# Access Compliance Report

## Public Rights-of-Way

### (Curb Ramps)

Intersection ID: 10030374	Main Street: LEVINE AVENUE OF THE ARTS	Cross Street: N/A	Location: W
ADA ID: 3112E80C4B90	Ramp Type: Perp	Initial Pass/Fail: Fail	Overall Compliance: No
Severity Score: 12.5			
Codes/Mitigation Info/Possible Solution		Field Measurements/Component Compliance

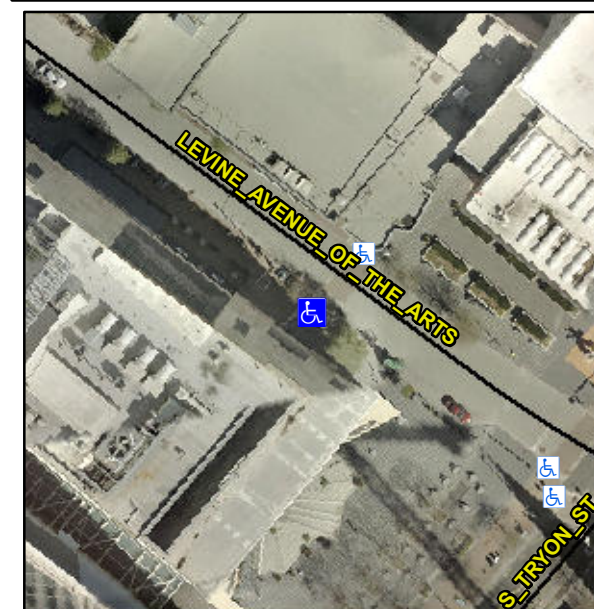
**Remove & Replace Entire Ramp.**

**R304.2.2**

Compliance	Description	Data	Compliance	Description	Data
N/A	Ramp Length (in)	77.0	No	Ramp Slope (%)	9.0
Yes	Ramp Width (in)	60.0	Yes	Ramp XSlope (%)	1.3
N/A	Flare Type LT	N/A	N/A	Flare Type RT	N/A
N/A	Flare Slope LT (%)	N/A	N/A	Flare Slope RT (%)	N/A
N/A	Flare Traversable LT?	N/A	N/A	Flare Traversable RT?	N/A
N/A	Landing Length (in)	N/A	N/A	DWS Provided?	N/A
N/A	Landing Width (in)	N/A	N/A	DWS Contrast?	N/A
N/A	Landing Slope (%)	N/A	N/A	DWS Length (in)	N/A
N/A	Landing X Slope (%)	N/A	N/A	DWS Full Width?	N/A
N/A	Landing Curb? (Y/N)	N/A	N/A	DWS Offset (in)	N/A
N/A	Shared Landing?	N/A			
N/A	Gutter Ponding?	N/A	N/A	Gutter Slope (%)	N/A
N/A	Gutter Lip Ht (in)	N/A	N/A	Gutter X Slope (%)	N/A
N/A	Painted X Walk1?	Yes	N/A	Painted X Walk2?	N/A
	X Walk 1 Direction	To NE		X Walk 2 Direction	N/A
N/A	X Walk 1 Width (in)	147.0	N/A	X Walk 2 Width (in)	N/A
	X Walk 1 Slope (%)	2.2		X Walk 2 Slope (%)	N/A
	X Walk 1 X Slope (%)	2.3		X Walk 2 X Slope (%)	N/A
